ADDENDUM NO. 2
to
CONTRACT DOCUMENTS

for
ADDITIONS AND RENOVATIONS
to the
COMMUNITY PARK ELEMENTARY SCHOOL
located at 372 Witherspoon St, Princeton, NJ 08542

for
PRINCETON PUBLIC SCHOOLS
PRINCETON, MERCER COUNTY, NEW JERSEY

Issued: January 23, 2026

Drawing Number
C-2.0

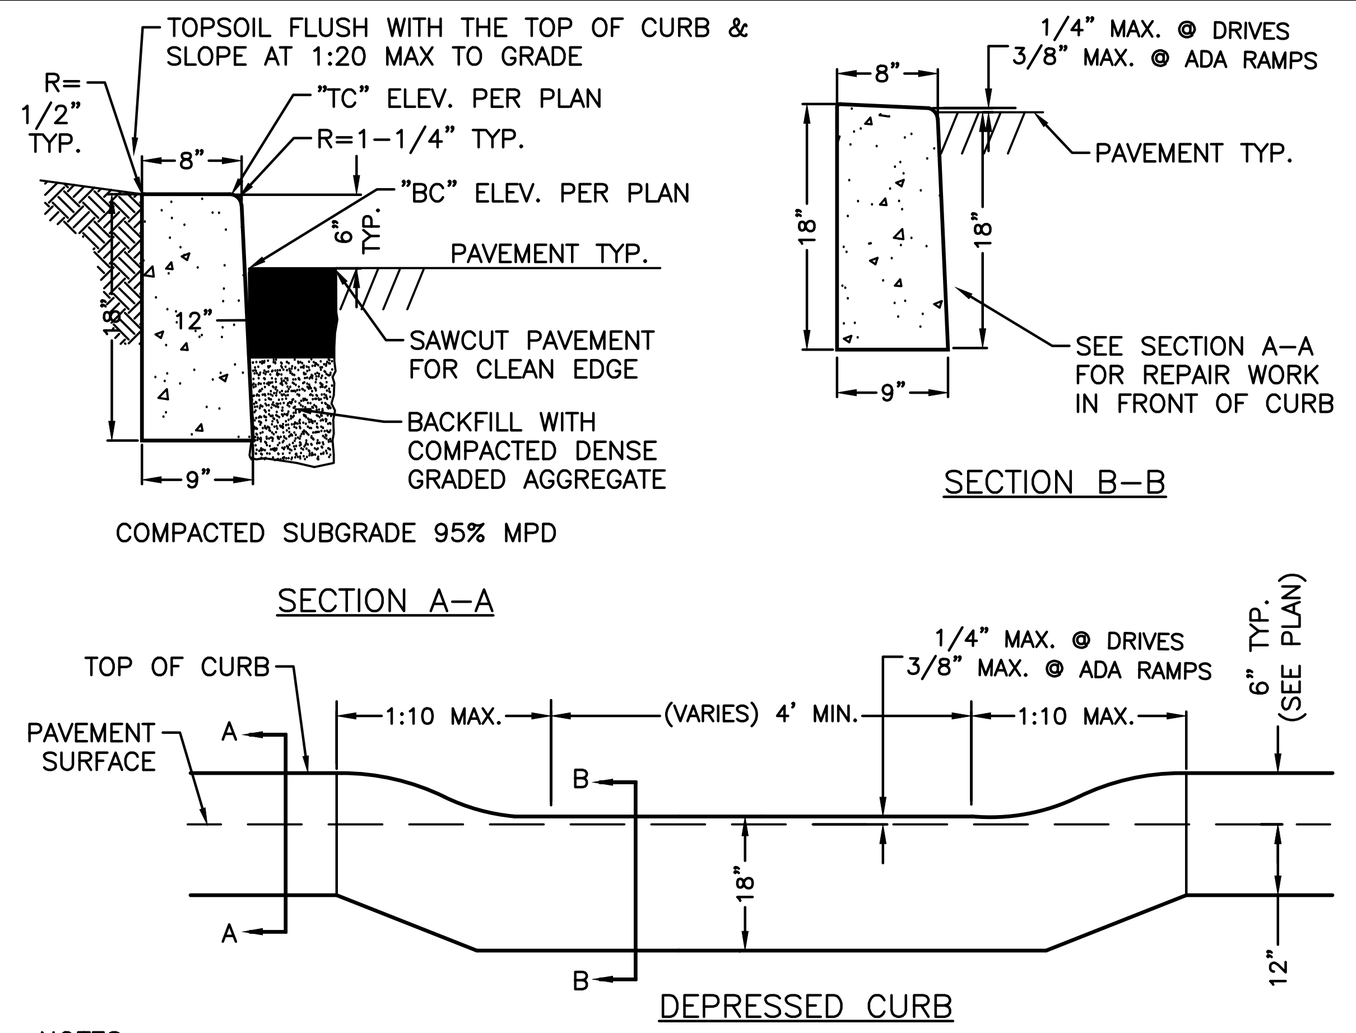
13. Question: On Dwg C-2.0 Demolition plan – top left of drawing calls for Demolish Existing Fence. Please clarify if the entire fence line on left is being demo or portion like other spots on the drawing.

Response: FVHD does not provide quantities. Visit the project site. Refer to revised sheet C2.0 (attached to this Addendum) with fence demolition scope clarified.

Drawing Number
A003

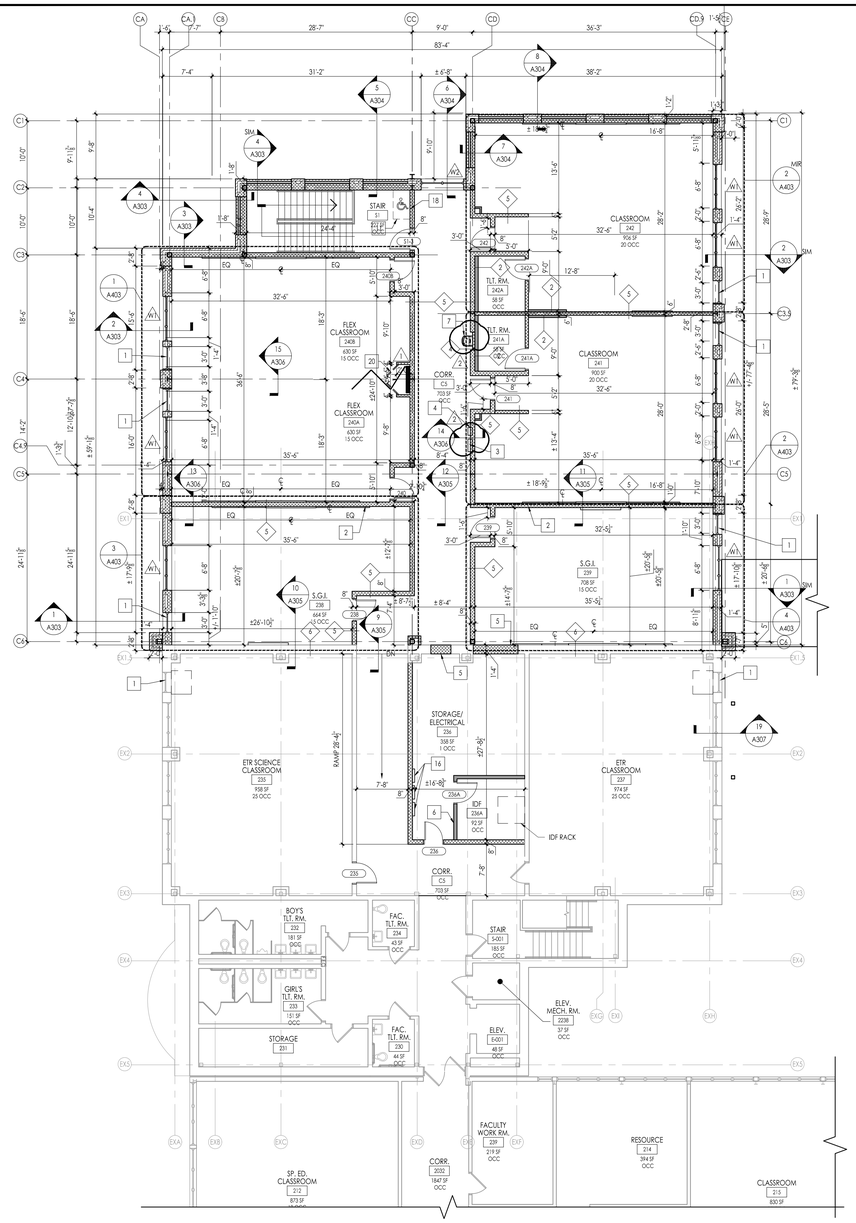
32. Question: Dwg detail 1/A-003 calls for Exterior Mobile Outdoor white board. Please provide sizes and manufacturer names.

33. Question: Please provide width of built-in bench for section marked 5/A-003 as plans do not indicate width on 1/A-003.

Response: See revised drawing A003, attached to this Addendum.

Response: Bench widths are shown on the left side of the plan.

Drawing Number
A103

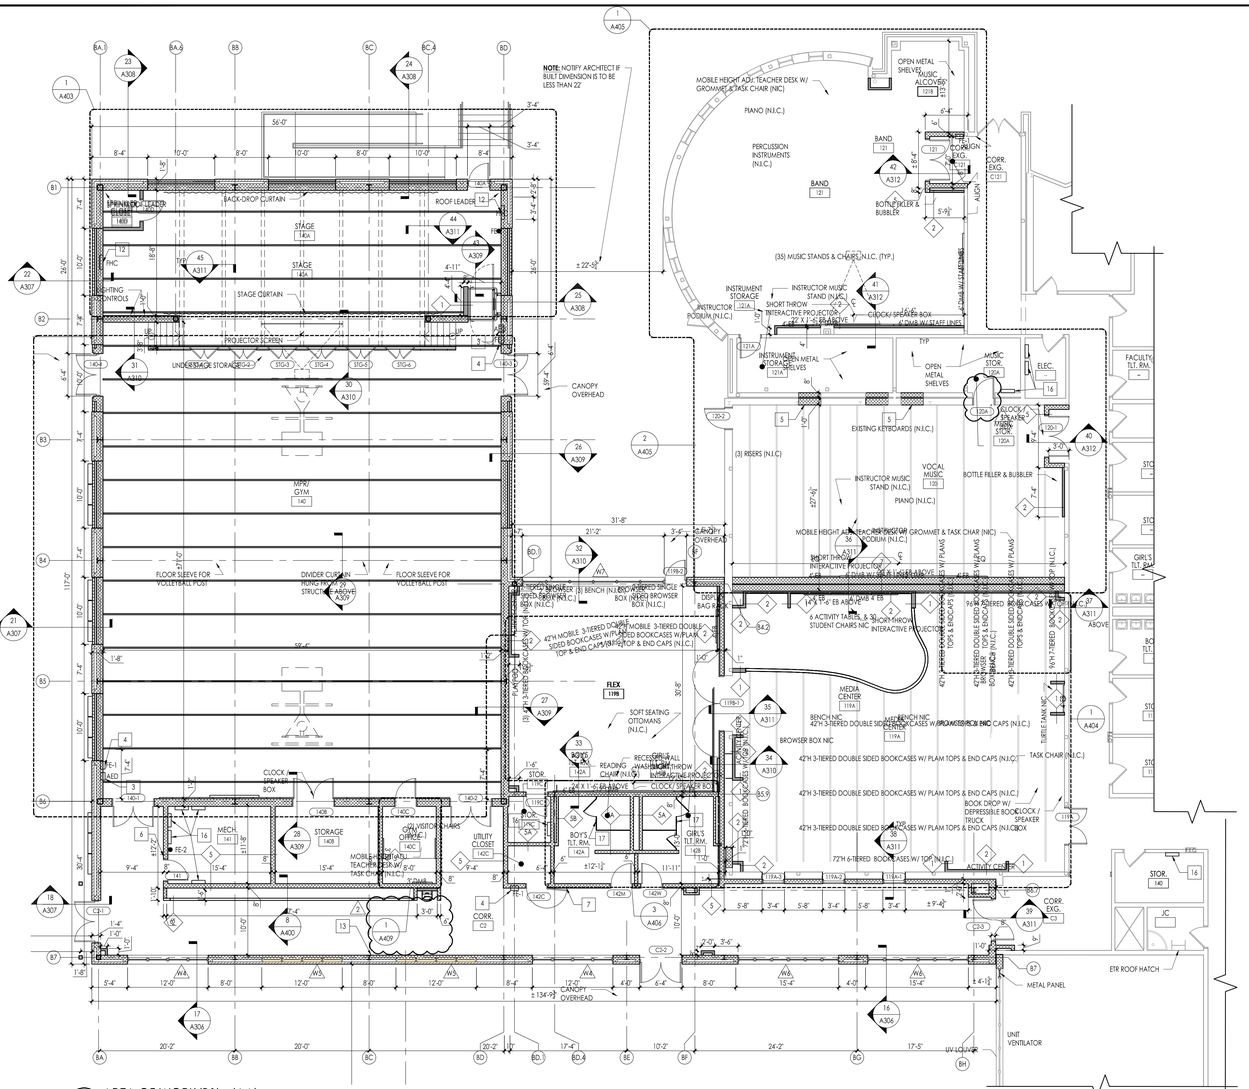
34. Question: Dwg A-103 & A-104 indicate FE-2 on plan legend without any descriptions. Please confirm this is without Fire Extinguisher Cabinet and wall mounted only.

35. Question: Dwg detail 2/A-103 SGI-131 indicate cross section with XX/A30X, please provide correct C/S number and drawing.

Response: FE-2 is a fire extinguisher on a bracket – no cabinet.

Response: See revised Drawing A103, attached to this Addendum.

Drawing Number
A308

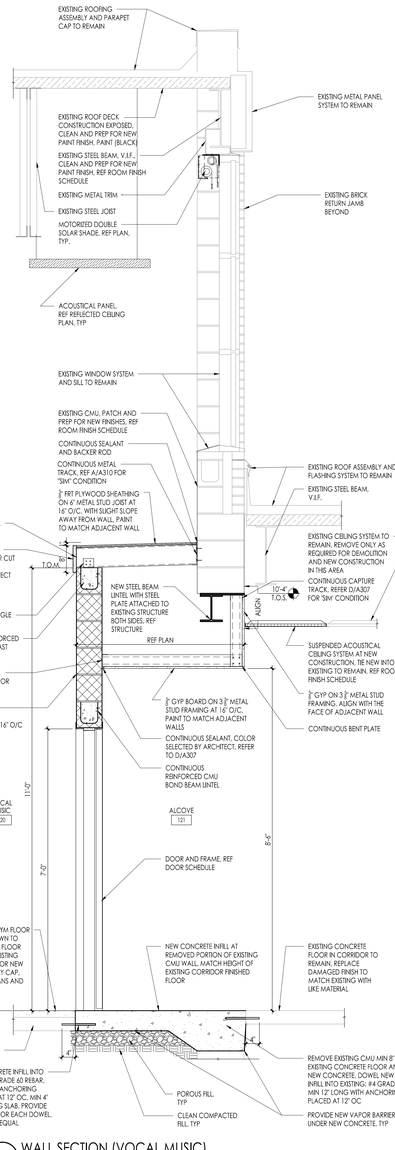
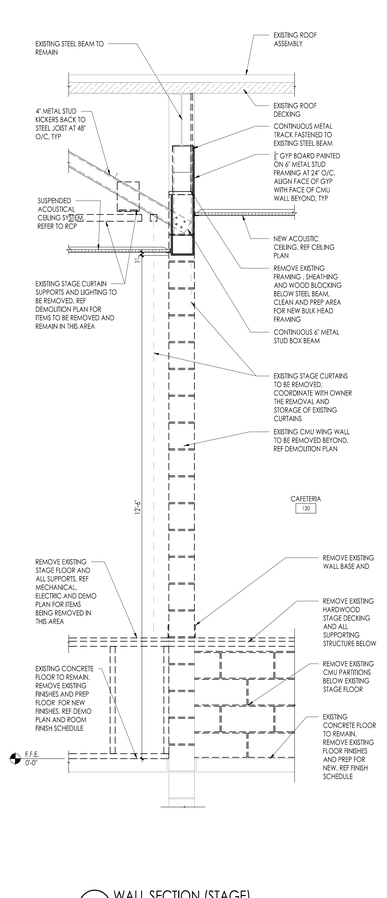
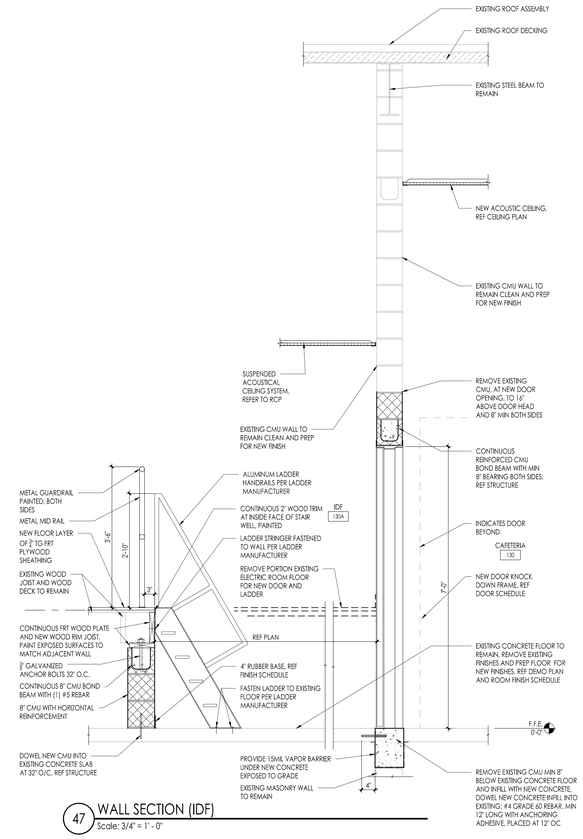
1. Question: Specification Section 07111, Bituminous Dampproofing is provided but the drawings and details do not include dampproofing. However, bentonite waterproofing is shown on the details, but no specification is provided. (Please note that bentonite manufacturers typically do not want bentonite used on CMU walls. Please clarify which product should be used and provide the associated specification or updated details depending on which product is to be used.

37. Question: Please provide Spec 05400 for Cold-Formed Metal Framing, 09250 for Gypsum Boards, 09300-for Tile and Bentonite Waterproofing per detail 25/A-308.

Response: See revised Wall Section 25 / A308 and Details 43 and 44 / A312, attached to this Addendum.

05400 does not apply as metal framing for gypsum board is included in Section 09250.
    09300 does not apply to this project.
    See Specification Section 09661 for Resilient Quartz Tile Flooring.
    See new Specification section 09250 (Gypsum Drywall) attached to this Addendum.
    Bentonite - See revised Drawings A308 and A312, attached to this Addendum.

A312

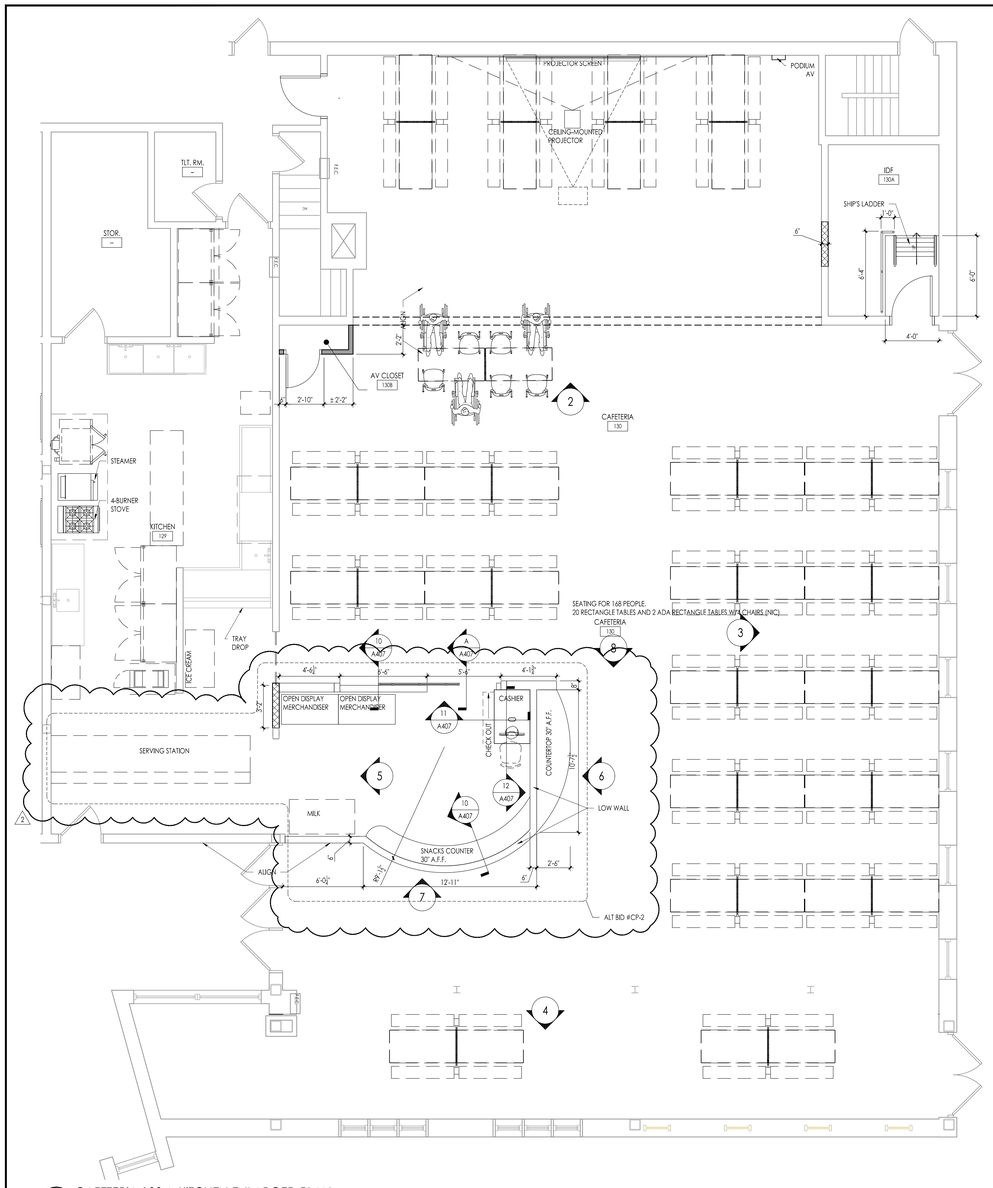
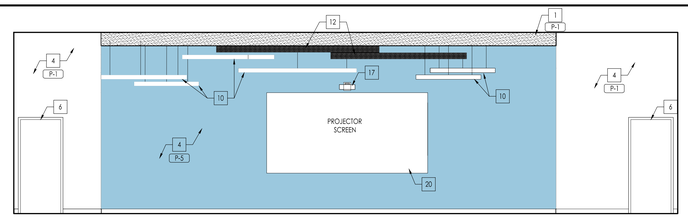
41. Question: Alternate 2, Serving Line Improvements states to add the amount to the base bid to provide and install the Cafeteria Serving Line Improvements as indicated on various drawings and specifications. Please provide the drawings and specifications for the Alternate work requested.

Response: See Revised Drawing A407, attached to this Addendum.

12 PRE-MANUFACTURED RAMP SECTION
Scale : 1/2" = 1' - 0"

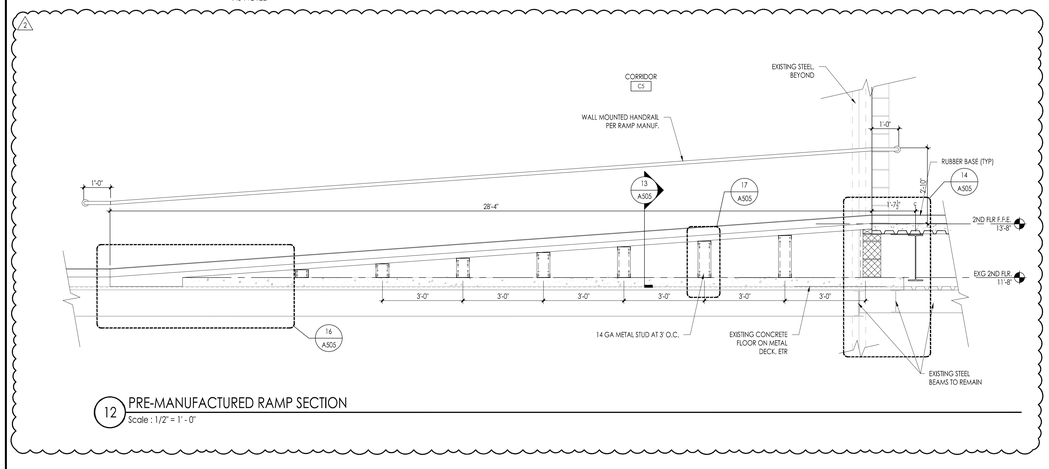
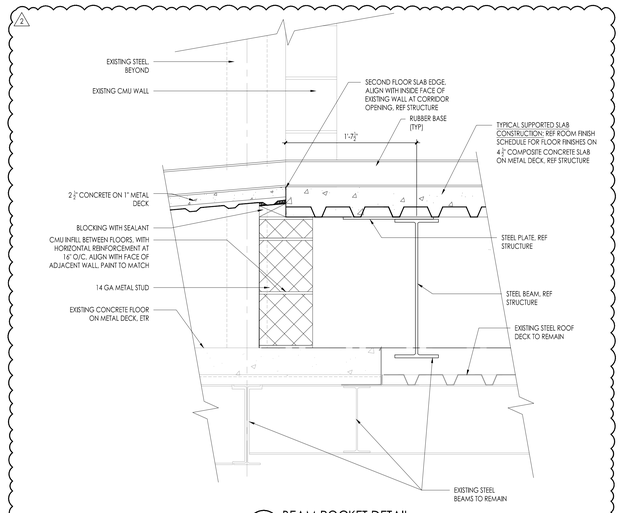
38. Question: Detail 3 on Drawing A201 calls out Pre-Manufactured Aluminum Ramp in the corridor, please provide specifications.

Response: Ramp has been redesigned – see revised drawing A505, attached to this Addendum.

Drawing Number
A601

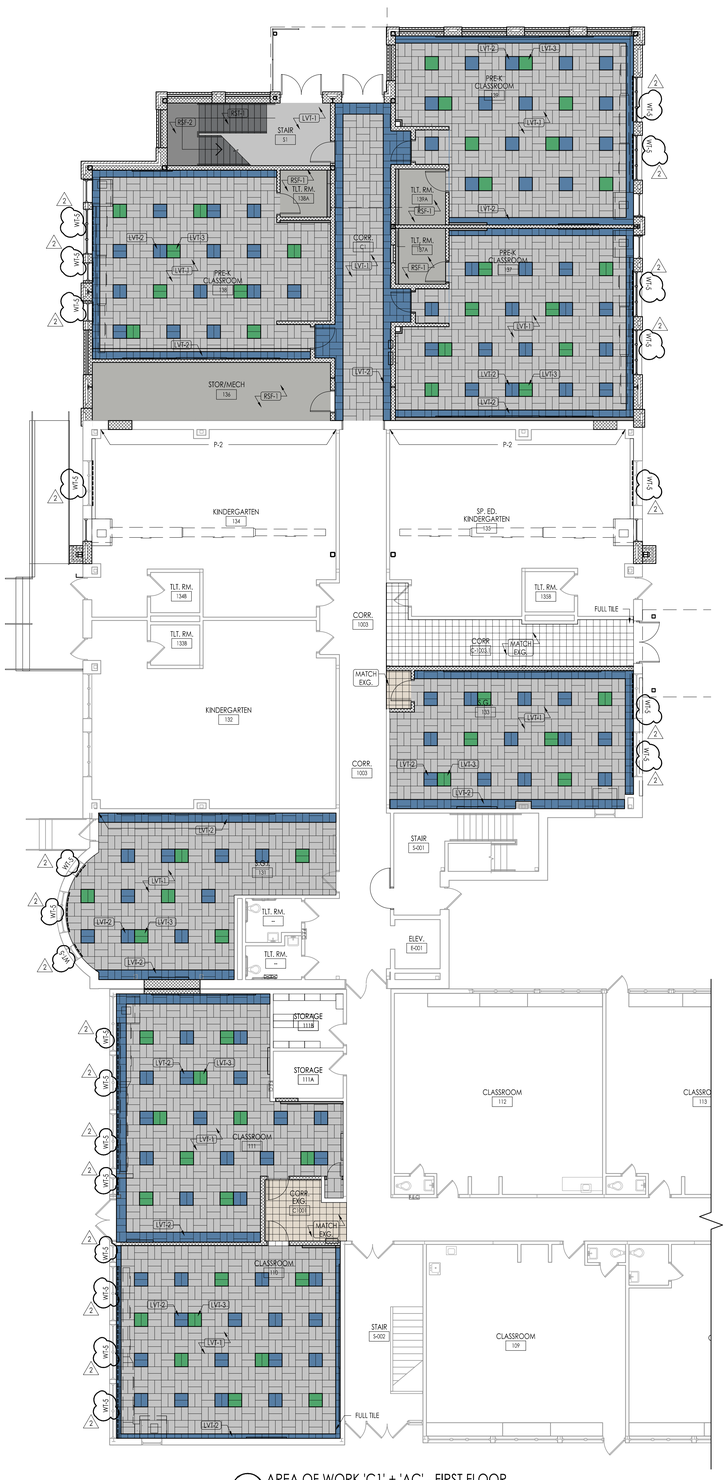
14. Question: On Dwg A-601 from door 235 – 242A and S1-3 indicates "space not found" please clarify.

15. Question: On A-601 signage details are found, please provide location of all signage and signage schedule to price out if this is by this contract.

Response: See revised drawing A601, attached to this Addendum.

Response: See revised drawing A601, attached to this Addendum.
